Change Order - Construction Manager-Adviser Edition

PROJECT (Name and address): East Hardin Middle School Elizabethtown, KY	CHANGE ORDER NUMBER: 012 INITIATION DATE: May 8, 2020	OWNER: <input checked="" type="checkbox"/> CONSTRUCTION MANAGER: <input checked="" type="checkbox"/> ARCHITECT: <input checked="" type="checkbox"/> CONTRACTOR: <input checked="" type="checkbox"/> FIELD: <input checked="" type="checkbox"/> KDE: <input checked="" type="checkbox"/>
TO CONTRACTOR (Name and address): Edgar Belle LLC 583 Ballard Lane New Haven, KY 40051	PROJECT NUMBERS: BG 18-267 / 201752-01 CONTRACT DATE: April 18, 2019 CONTRACT FOR: BP 030-02 General Trades

Costs associated with installing horizontal 3 x 3 L25 ga at masonry to panel transitions. (PR#9)

Architect's Project Number: 201752.01
Proposal Request Number: 009

TYPICAL STONE SILL @ FIBER CEMENT

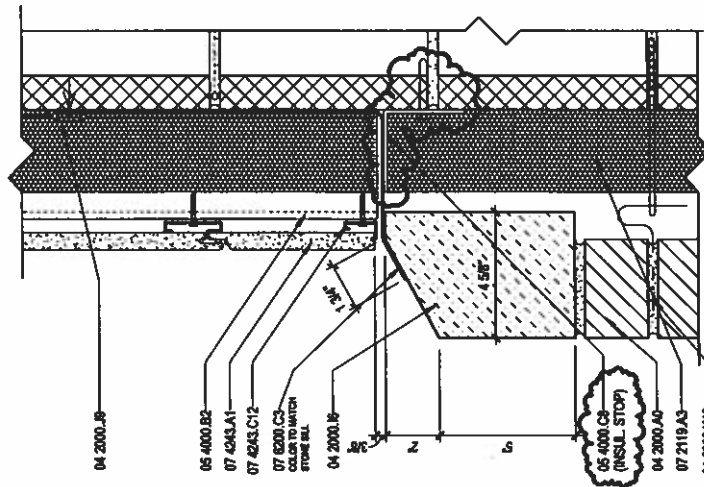
Provide a cold formed angle for an insulation stop where the Fiber Cement meets the stone sill. See revised detail A/A-531.
